# UNITED STATES PATENT AND TRADEMARK OFFICE

APPLICATION NO.	FILING DATE	FIRST NAMED INVENTOR	ATTORNEY DOCKET NO.	CONFIRMATION NO.
10/556,005	11/08/2005	Atul Katoch	NL 030576	5020

## Office Action Summary

## **DETAILED ACTION**

Fig. Xa

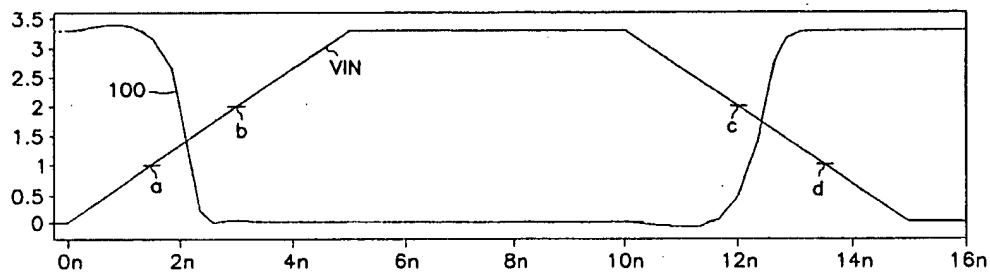
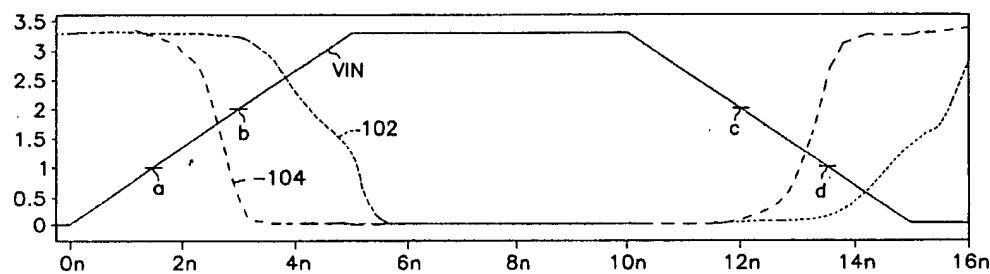
The drawings are objected to because Figure 7 is too condensed to see each specified signal at the times between 1-3ns and 5-6ns. The Examiner suggests either expanding Figure 7 (if possible) to provide one with the ability of differentiating the five

different signals or separating the signals on more than one stacked graph where signals can be view concurrently over the same time and voltage scale (the Examiner has provided an example of this for clarity).

Corrected drawing sheets in compliance with 37 CFR 1.121(d) are required in reply to the Office action to avoid abandonment of the application. Any amended replacement drawing sheet should include all of the figures appearing on the immediate prior version of the sheet, even if only one figure is being amended. The figure or figure number of an amended drawing should not be labeled as "amended." If a drawing figure is to be canceled, the appropriate figure must be removed from the replacement sheet, and where necessary, the remaining figures must be renumbered and appropriate changes made to the brief description of the several views of the drawings for
